**NUMBER:** 21-037-20

Transmission Case Oil Leak

This bulletin involves tightening the lower transmission bolts to updated torque specifications to possibly eliminate a leak at the case split line of the transmission.

2019 (VM) RAM ProMaster City

Fig. 4

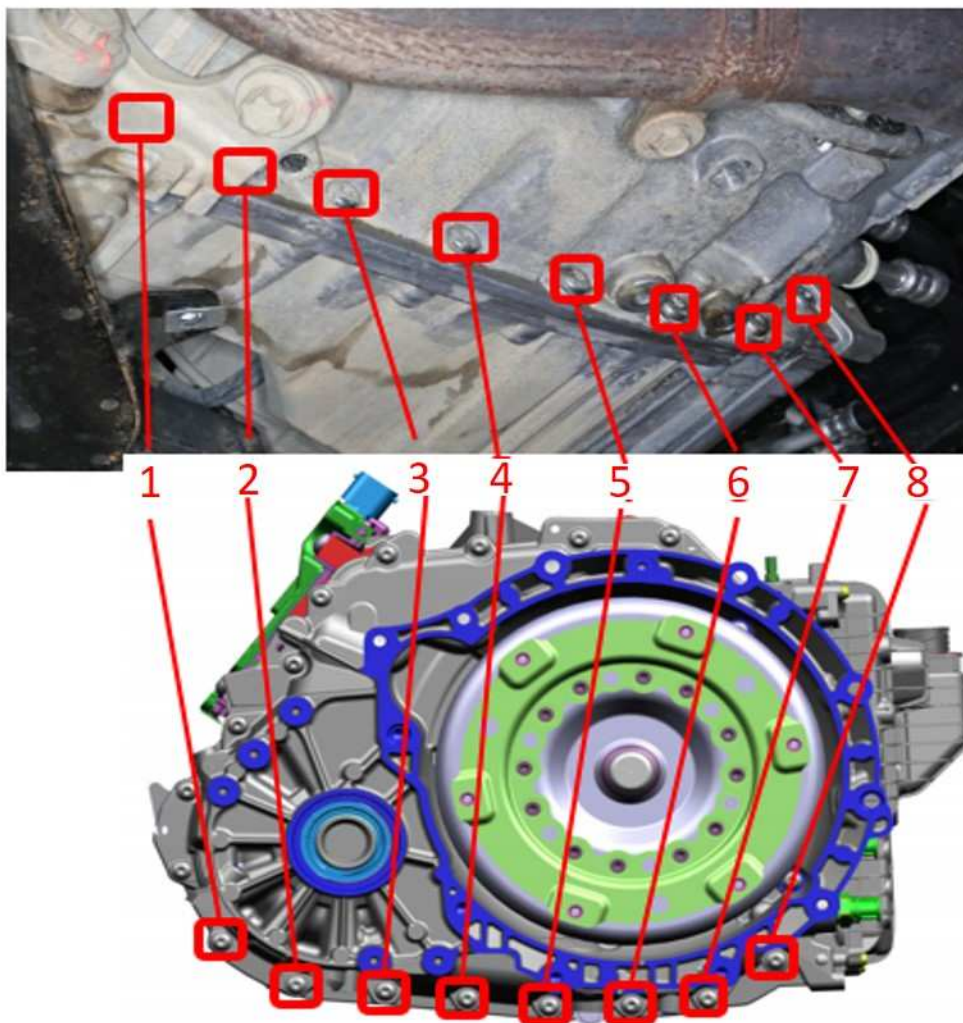
3. Starting at bolt #8 and then working to bolt #1, torque bolts to 35 N·m (26 ft. lbs.) (Fig. 4) .

**CAUTION! Do not rotate the bolts counter clockwise.**
